Appendix E

**DRAINAGE DESIGN AND ROAD
ALIGNMENT - PROVIDED BY CAPITA
/ JACKSON**

Subject CS/099505 Drainage Strategy

A29 Realignment Scheme - SuDS Management Train

DRAINAGE PROPOSALS

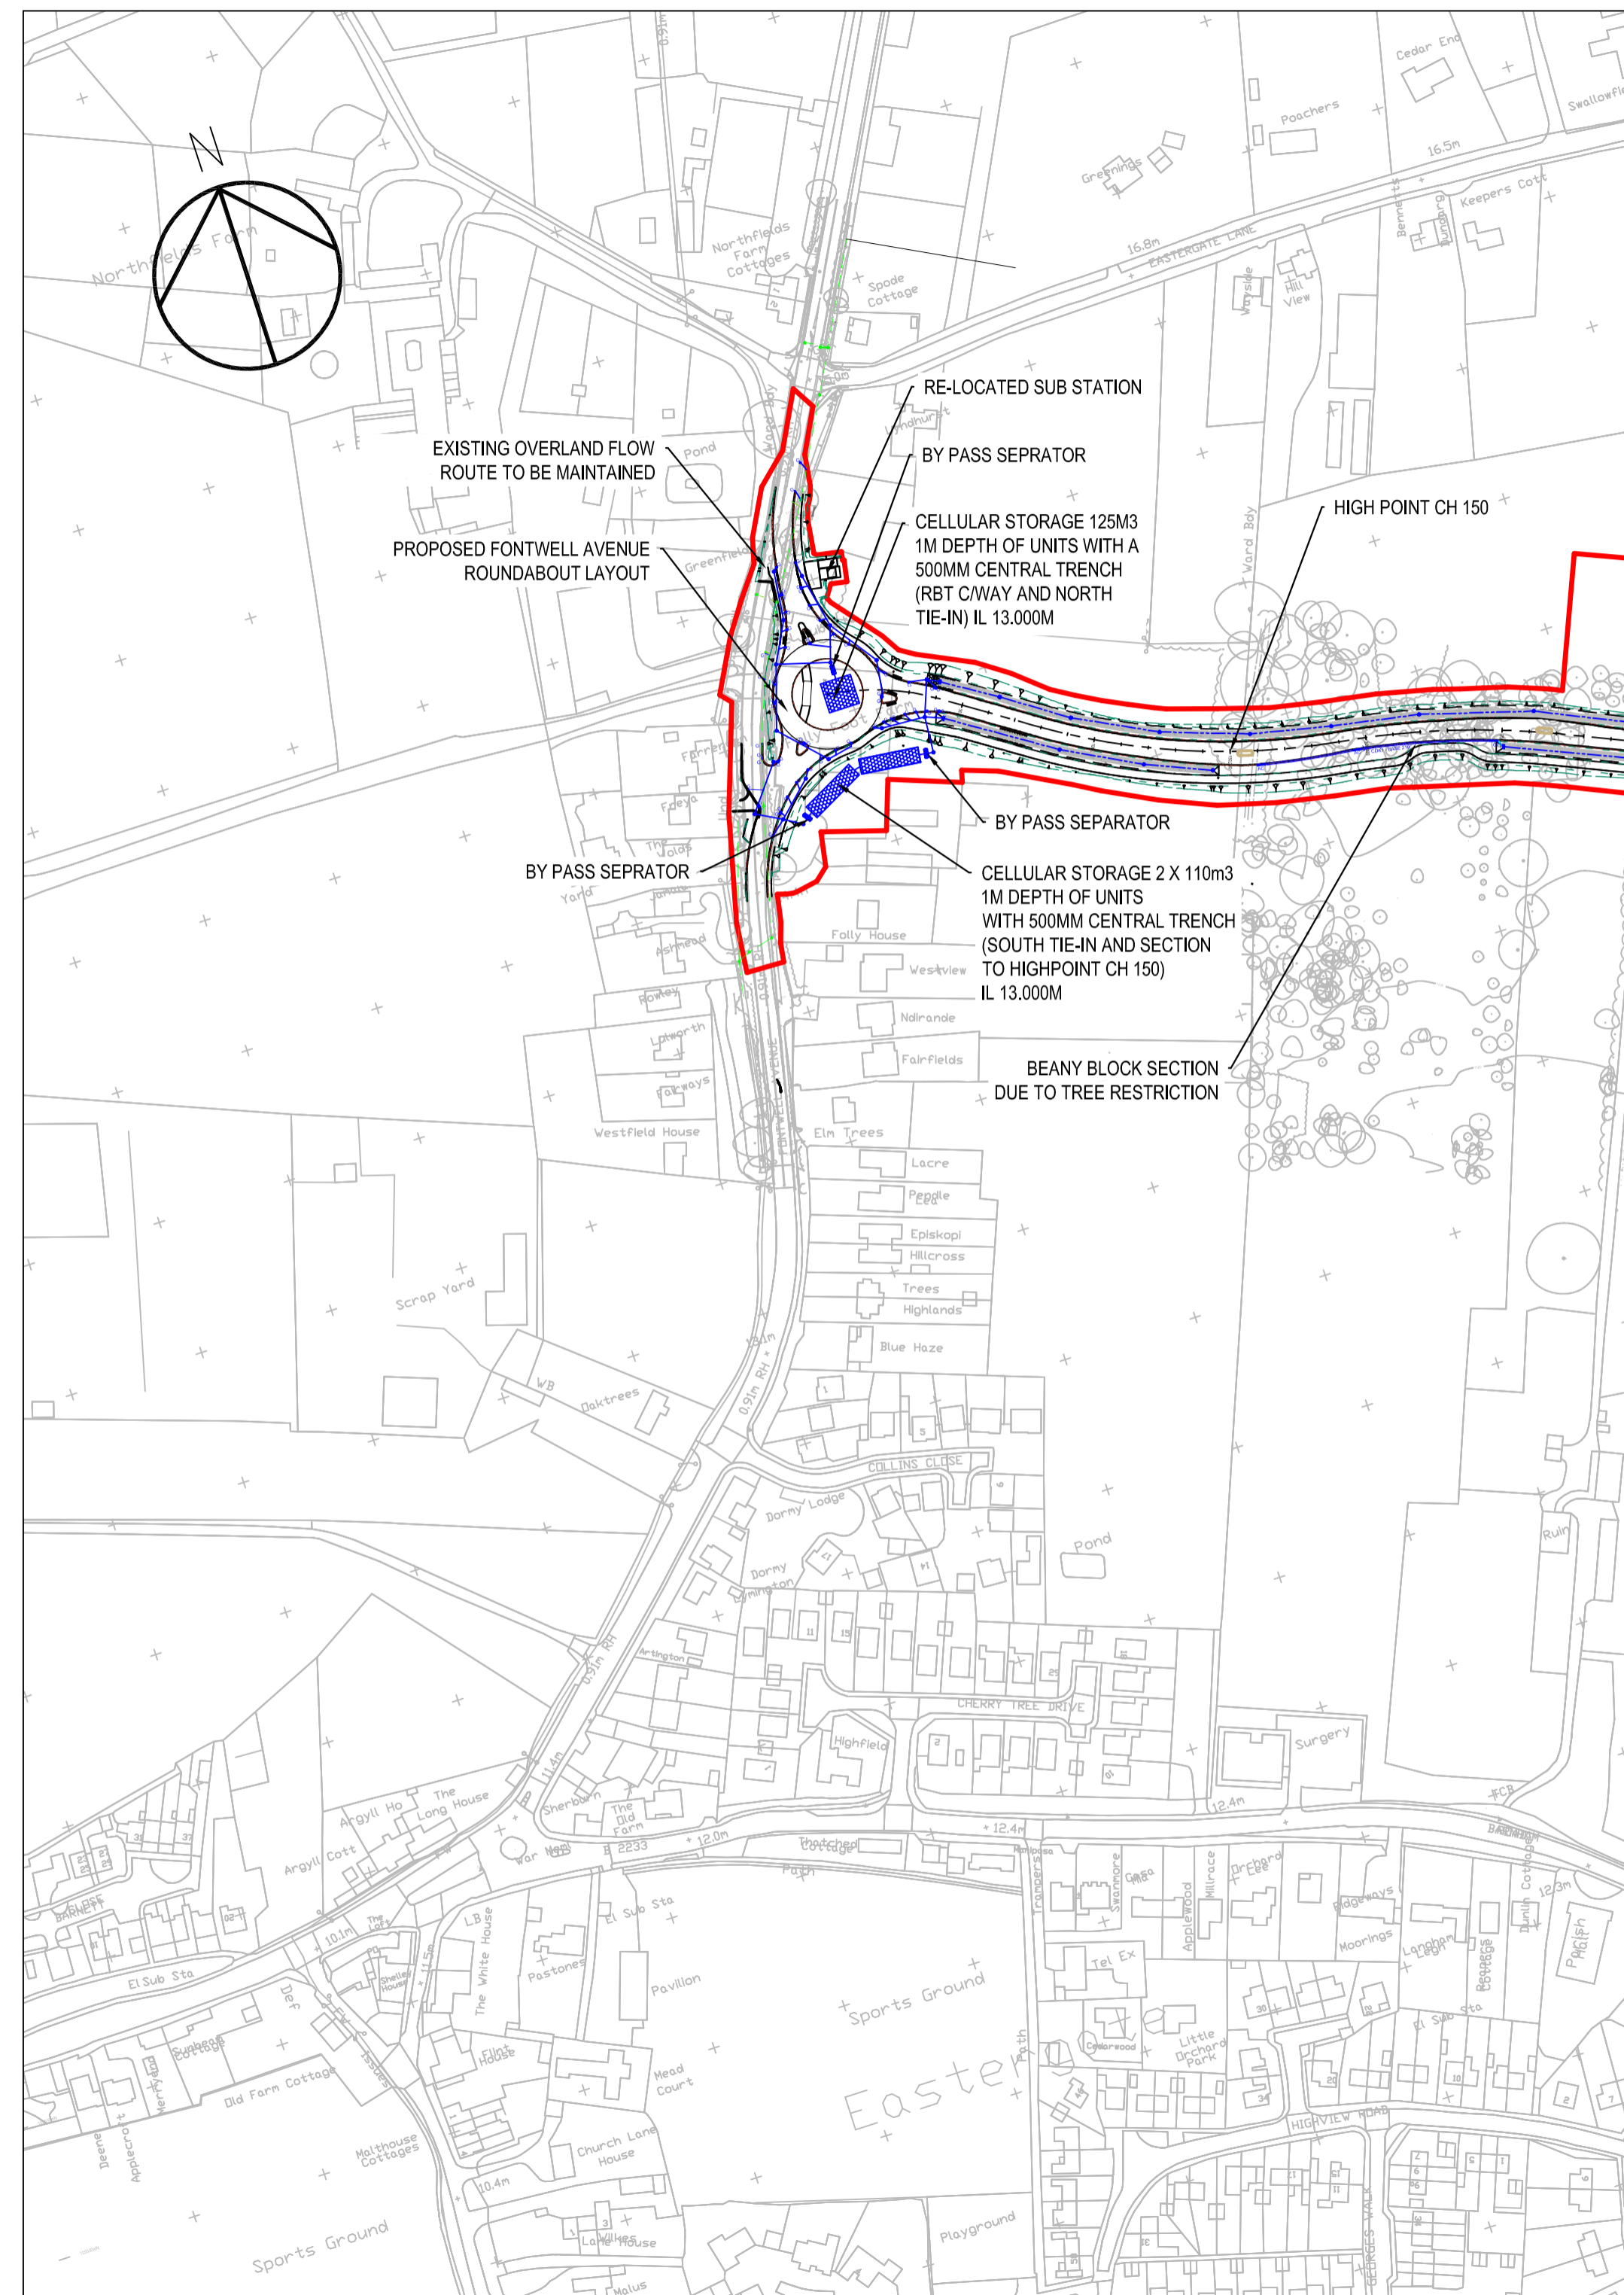
1. Our preference would be for open features as opposed to crates (pond/tank 1).
2. Discharge to the Barnham Lane ditch from pond 3 – restrict discharge to QBAR (ie. 1 in 2.3 year storm) bearing in mind the known issues downstream. I appreciate that this will need to be run past WSCC highways due to their min. 5 l/s discharge requirement, however, a hydrobrake in combination with upstream measures can be utilised to reduce any risk of blockage to the control, as that is probably their primary concern.

4. Whilst ponds 3 and 4 are relying attenuation/restricted discharge, infiltration must be utilised where ever possible in their respective catchment areas (taking into account item 3 above). A hybrid arrangement of infiltration and restricted discharge to watercourses is the likely solution.

5. Due to the shallow ditch to which pond 3 is going to discharge too, connection via a shallow channel/swale is probably going to be needed as opposed to pipework. Environment Agency approval will be required due to this section being 'main river'.

6. Has winter groundwater monitoring and infiltration testing been carried out south of Barnham Road, in order to inform the design of pond 4?

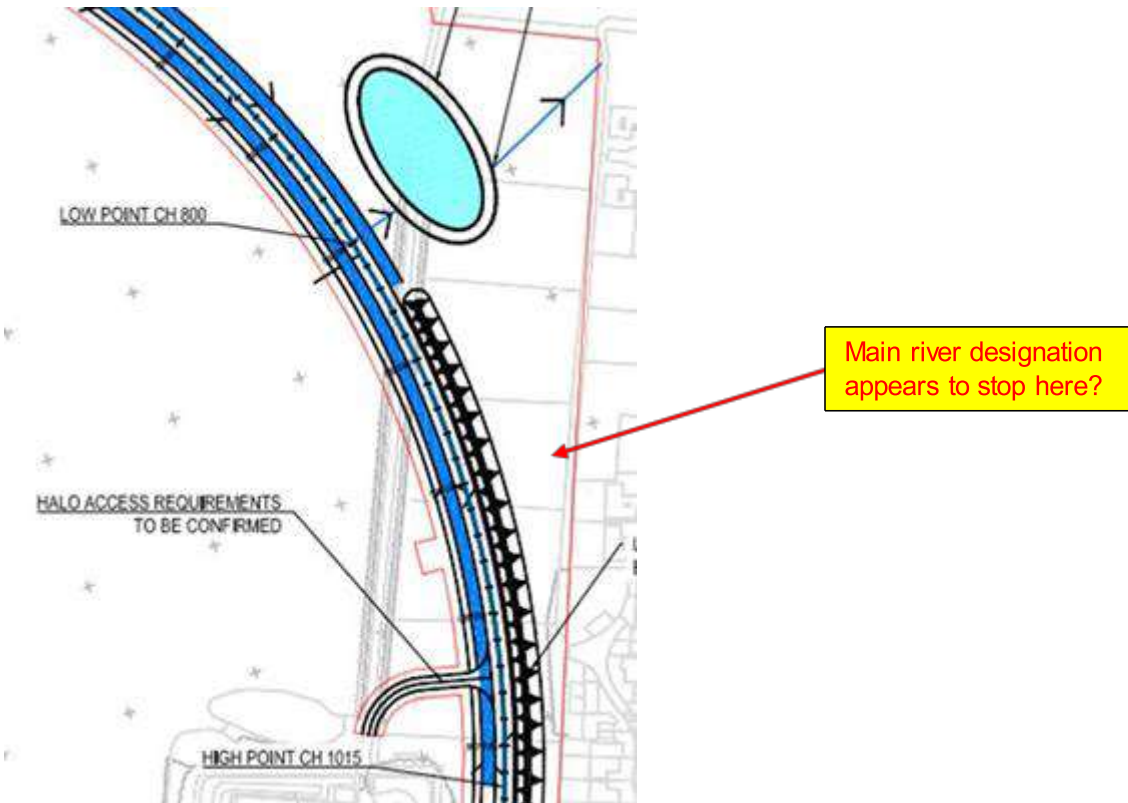
With regards to your comment concerning where the road route runs southwards past your main river (the blue line on your map with red arrow) – please can you explain further where you are referring to when talking about a culvert?

Seems our organisations have different meanings for the terms 'on line' When someone says 'on line' to the EA it's normally in reference to an existing watercourse whereas someone wishes to build a pond on line'of it. I can see from the plans that Pond 3 is not to be built on line of a watercourse, so therefore does not apply.

It is noted that in Capita's Drainage Strategy, reference is made to a Flood Risk Assessment (FRA) As a statutory consultee within the planning process this is not something that we have made comment on. There is potentially the tinniest amount of road shown as being possibly within the floodplain, although I really don't think it is significant enough to be having to look at any form of flood compensation. I would assume we will be consulted in due course when full details have been established.
